V.O.CHIDAMBARANAR PORT AUTHORITY

Sub: Construction of Rubble bund for reclamation of Dredged material at south of South breakwater at V.O.Chidambaranar Port – Reply to the Pre bid Queries - reg.

NAME OF WORK: CONSTRUCTION OF RUBBLE BUND FOR RECLAMATION OF DREDGED MATERIAL AT SOUTH OF SOUTH BREAKWATER AT V.O.CHIDAMBARANAR AUTHORITY REPLY TO PRE-BID QUERIES

CORRIGENDUM-I

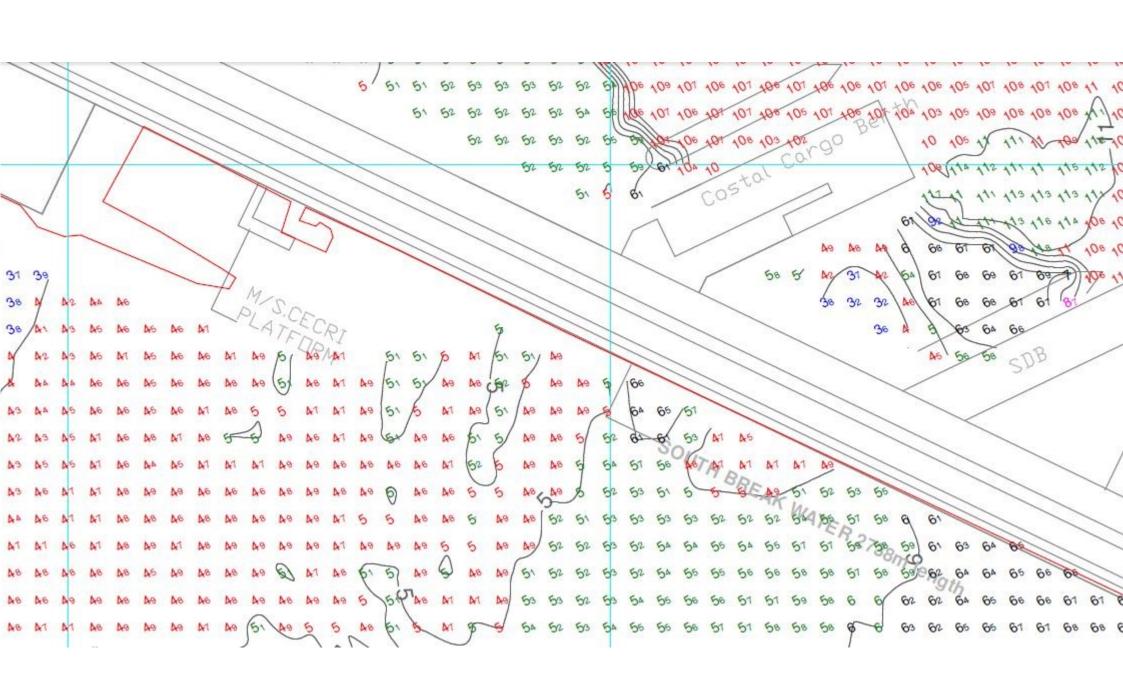
5.		General	Kindly provide bathymetry survey chart on the	Enclosed.
			proposed bund alignment line.	
6.		General	The access road for dumping stones will be	The access road for dumping stones will
